Project	IEEE 802.16 Broadband Wireless Access Working Group < http://ieee802.org/16 >	
Title	Secondary Management Connection Transport	
Date Submitted	2007-01-18	
Source(s)	Peretz Feder – ALU Phil Barber - Huawei	pfeder@alcatel-lucent.com , pbarber@huawei.com
Re:		
Abstract	Fixes to section 14.2.3	
Purpose	Adoption, Replacing IP signaling with simple payload	
Notice	This document has been prepared to assist IEEE 802.16. It is offered as a basis for discussion and is not binding on the contributing individual(s) or organization(s). The material in this document is subject to change in form and content after further study. The contributor(s) reserve(s) the right to add, amend or withdraw material contained herein.	
Release	The contributor grants a free, irrevocable license to the IEEE to incorporate material contained in this contribution, and any modifications thereof, in the creation of an IEEE Standards publication; to copyright in the IEEE’s name any IEEE Standards publication even though it may include portions of this contribution; and at the IEEE’s sole discretion to permit others to reproduce in whole or in part the resulting IEEE Standards publication. The contributor also a

14 **Figure 477—SMC IP address signaling transport and notification**

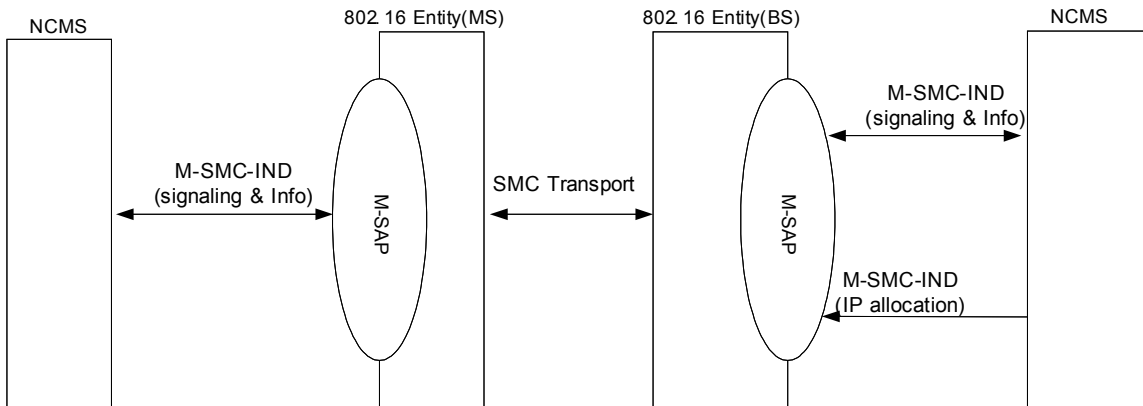
8 These primitives are provided when the IP connection is managed by the secondary management connection. It is
9 available for both IPv4 and IPv6.
